Re: APPROVAL OF PETITION FROM BISHOP'S HILL, LLC. – REQUESTING PLANNED DEVELOPMENT DISTRICT ON PARCELS AL-56-2 1921 RIVERSIDE DRIVE

Bishop's Hill Planned Development District

Preliminary PDD Review – Staff Comments

Site: 1921 Riverside Drive (Parcel AL-56-2)
Developer: Bishop's Hill, LLC.
Attn. Keith Garot

PDD Layout

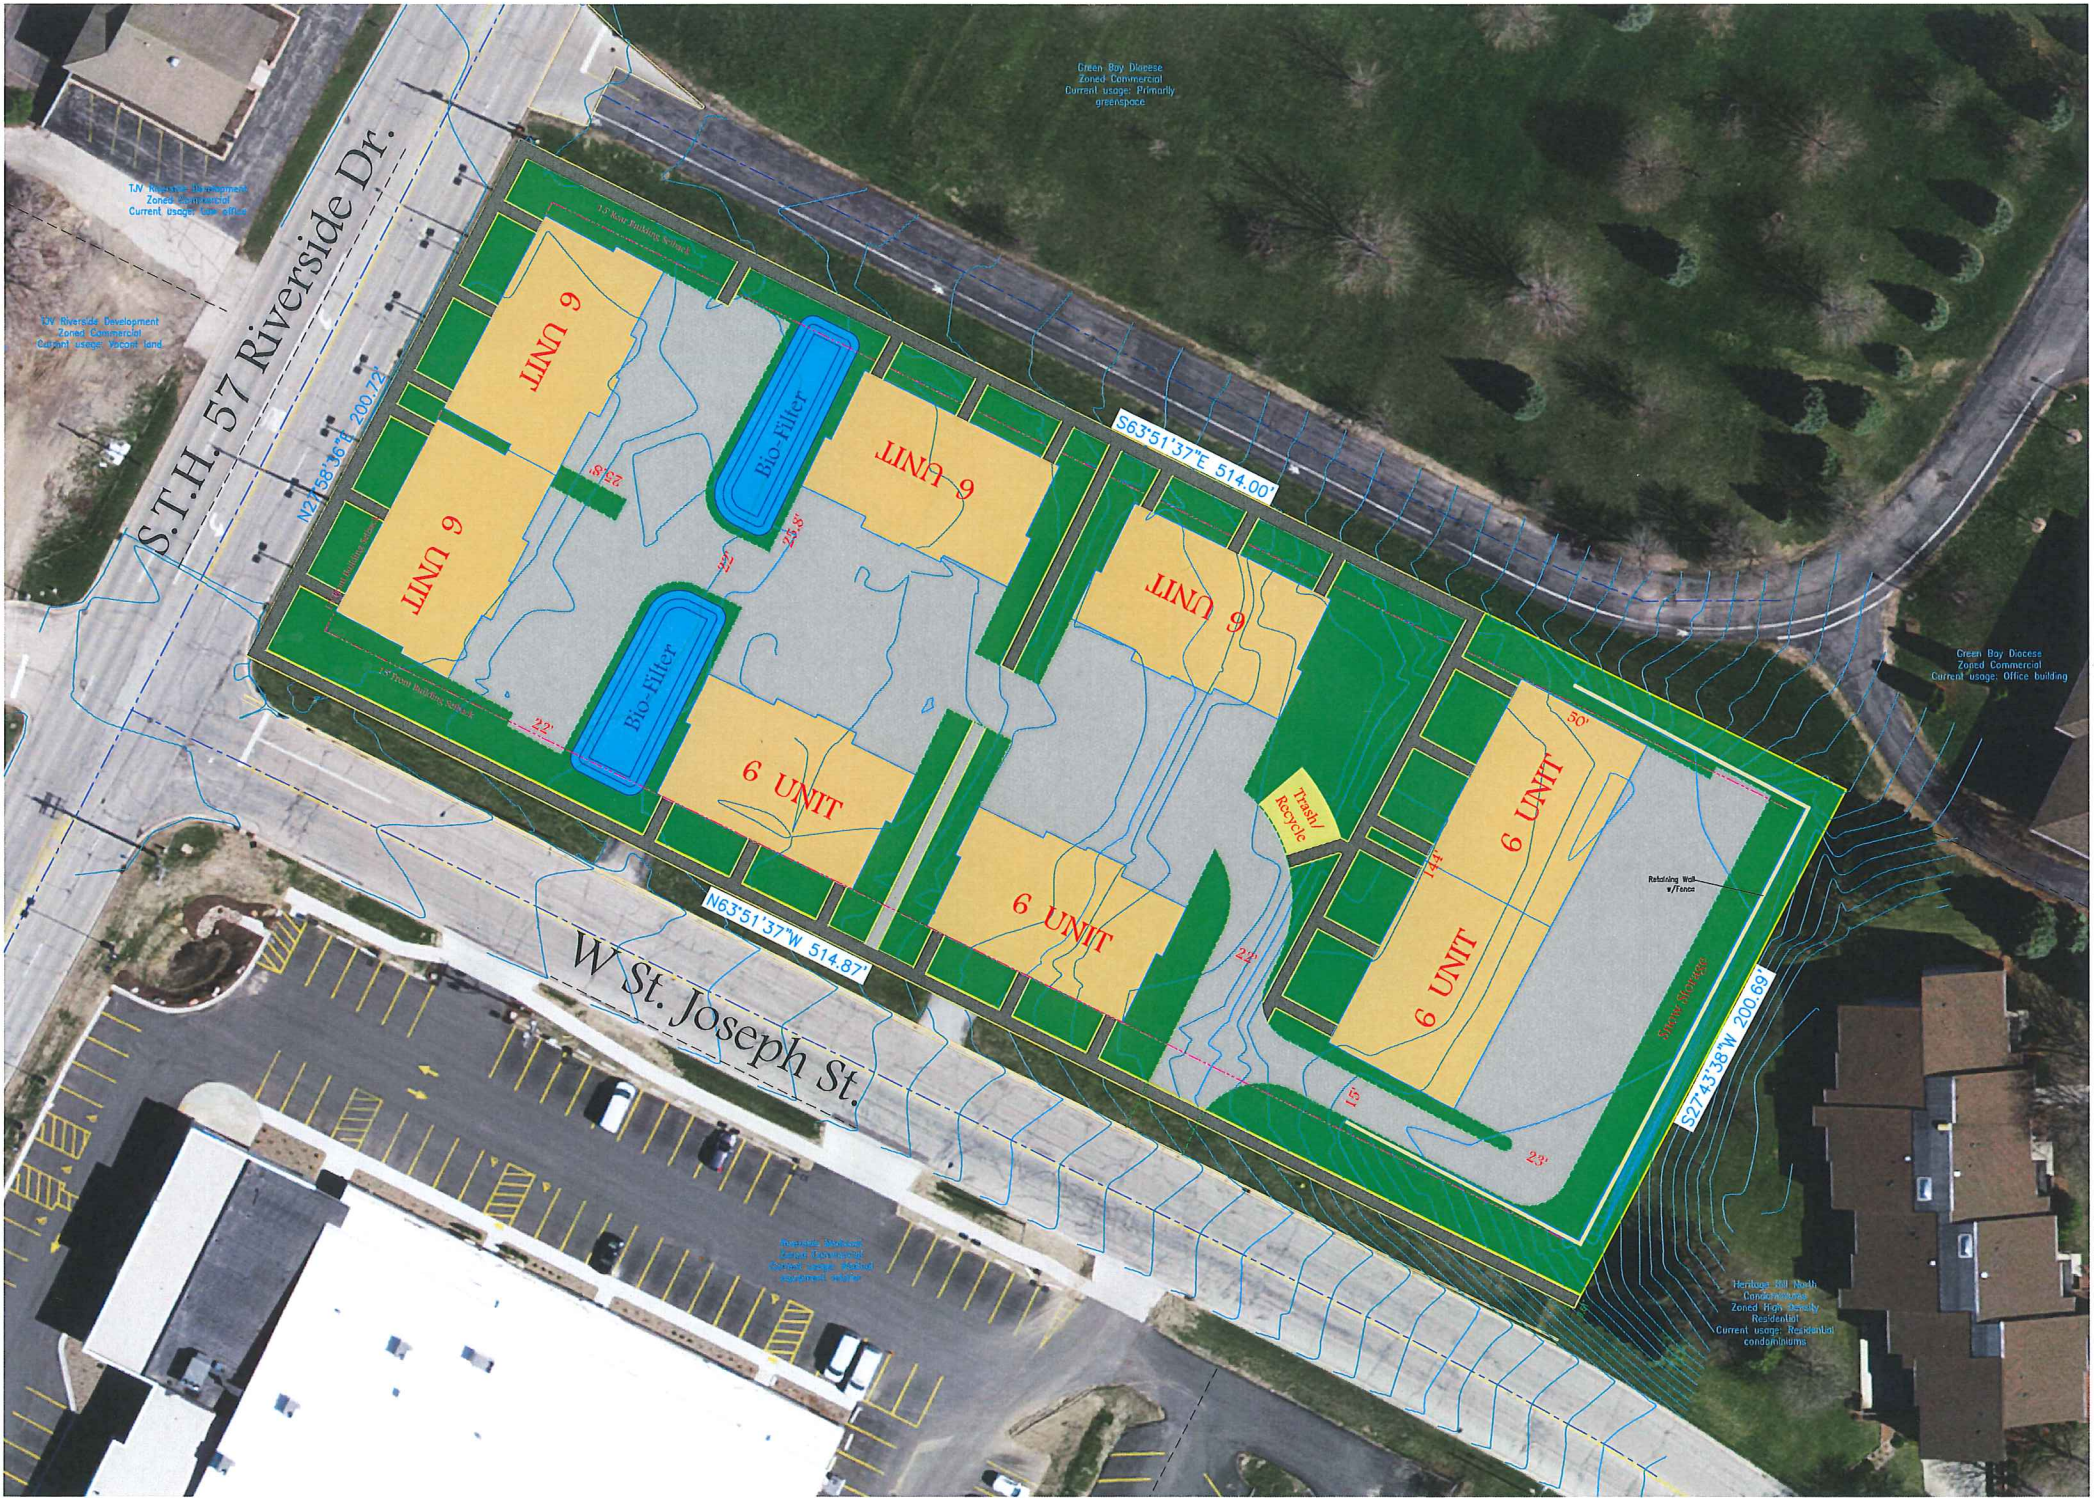
- The use is an allowed and existing use in the surrounding properties.
 - The setback is closer than what is allowed in the appropriate zoning district for the proposed use, but smaller setbacks are called for in the Comprehensive Plan.

- The massing of the buildings is broken up by architectural variations in the building.
 - Pedestrian access to the buildings is provided.
 - Green space and parking is adequate.

- Items to keep in mind for final approval:
 - Vinyl siding is proposed. Vinyl can be considered, but should be a thick grade, in the range of 0.045-0.055.

- The trash enclosure should be screened using the same masonry materials used in primary structures.
 - Landscaped islands should be provided where practical to break-up the expanse of asphalt.

- Public Works Department review:
 - Concerns for the preliminary approval:
 - Traffic plan should be discussed (e.g. access, traffic volumes, any DOT limitations if applicable).

2B

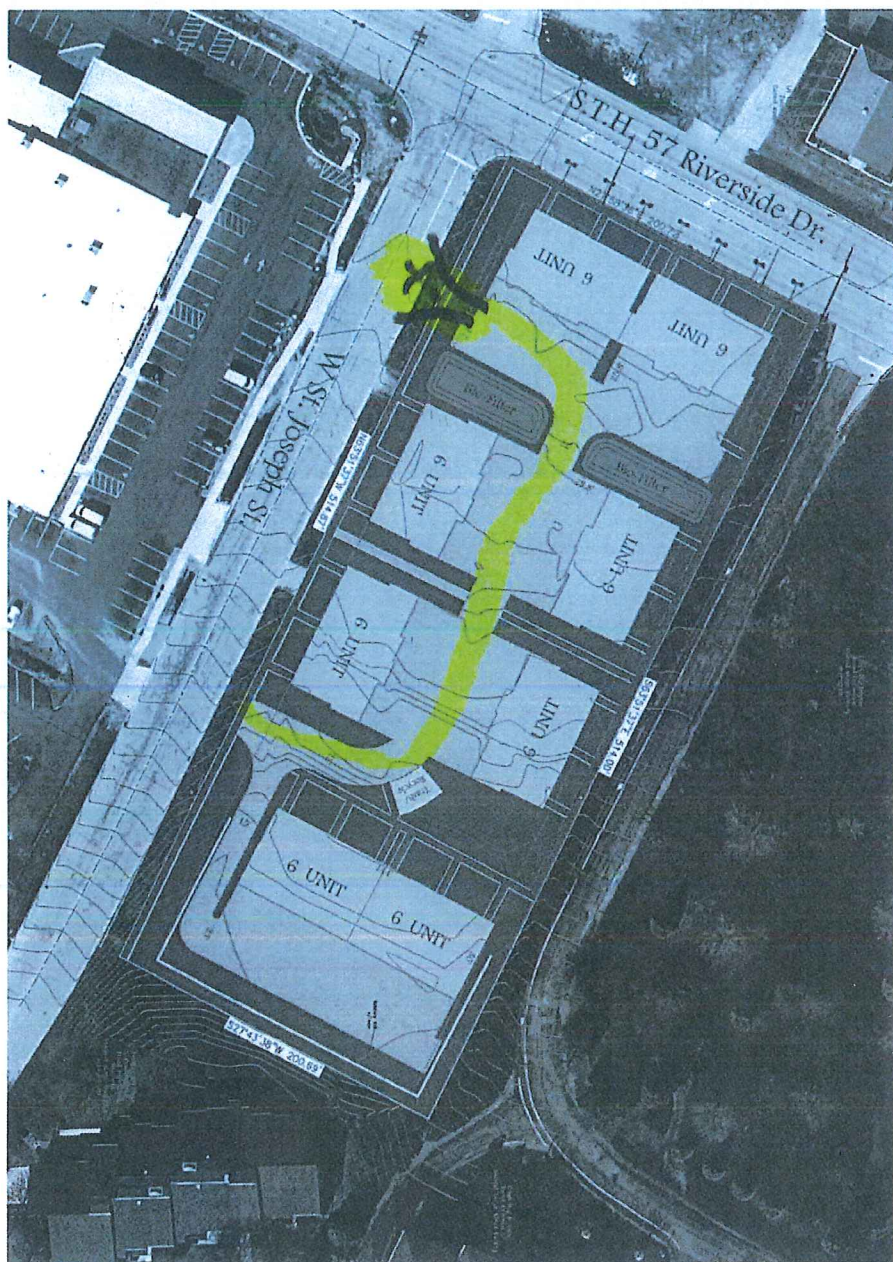
- Fire Department review:
 - Concerns with maneuvering rigs through two sets of buildings and around the corner to get equipment out of the apartment complex. A secondary ingress/egress to the apartment complex located on West St. Joseph Street would address these concerns. See attachment 2B.

- The size and placement of existing site utilities are limited and may not be useable in current state.
- A grading plan, a utilities plan for service to the site, an erosion control plan, and a post-construction stormwater management plan—all of which must be in an approvable form – will need to be provided. Note that the utilities will be a somewhat complex design, as will the stormwater plan because of the Fox River TMDL.
- If a secondary ingress/egress is provided, as noted in the Fire Department comments, it should be setback a minimum of 60' from the intersection.
